**FEDERAL AVIATION ADMINISTRATION
AIRWORTHINESS DIRECTIVES
SMALL AIRCRAFT, ROTORCRAFT, GLIDERS,
BALLOONS, & AIRSHIPS**

BIWEEKLY 2009-13

Figure 1 - Correct Installation of Clip for Box Beam

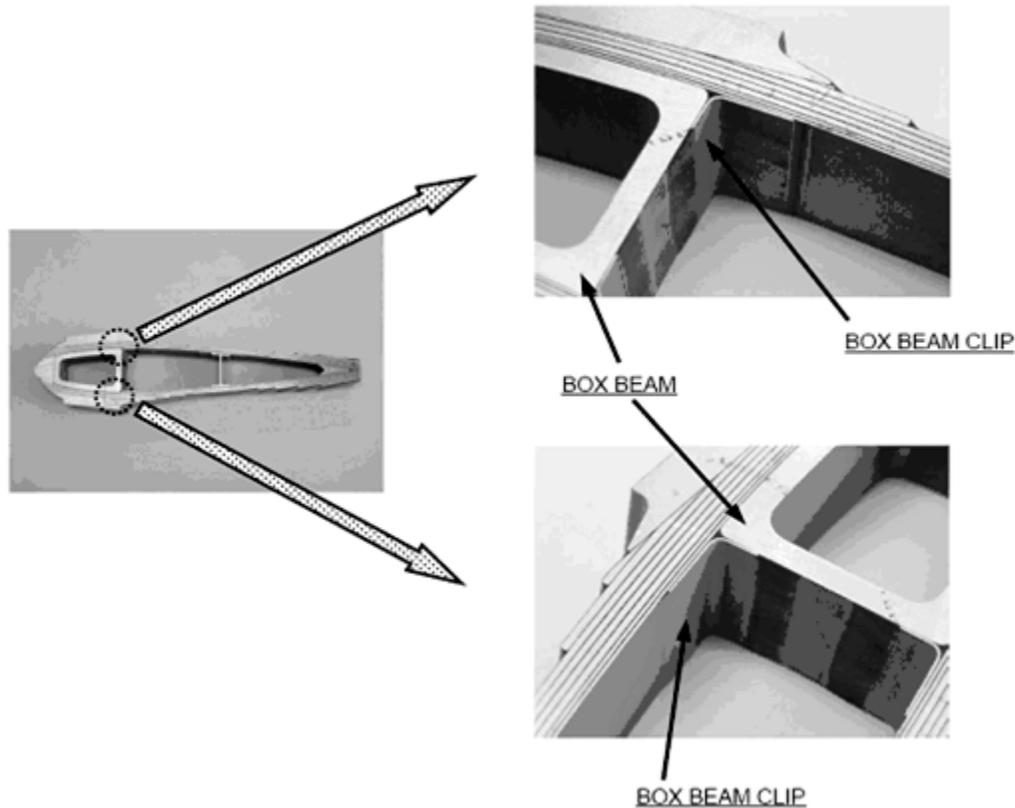
(a) Within 10 hours time-in-service (TIS), visually inspect the entire length of each upper and lower clip of each main rotor blade from the main rotor blade tip to the root by following Part II of the Accomplishment Instructions, paragraphs 1. through 8., of Bell Helicopter Textron, Inc. Alert Service Bulletin No. 47-08-25, dated May 26, 2008 (ASB) and referring to the depictions in Figures 1 and 2 of the ASB and Figure 1 of this AD for correct installation.

Note: Figure 3 of the ASB depicts a clip installed incorrectly.

(b) Before further flight, if you find a main rotor blade with an incorrectly installed clip, replace that unairworthy main rotor blade with an airworthy main rotor blade that has a clip that is installed correctly.
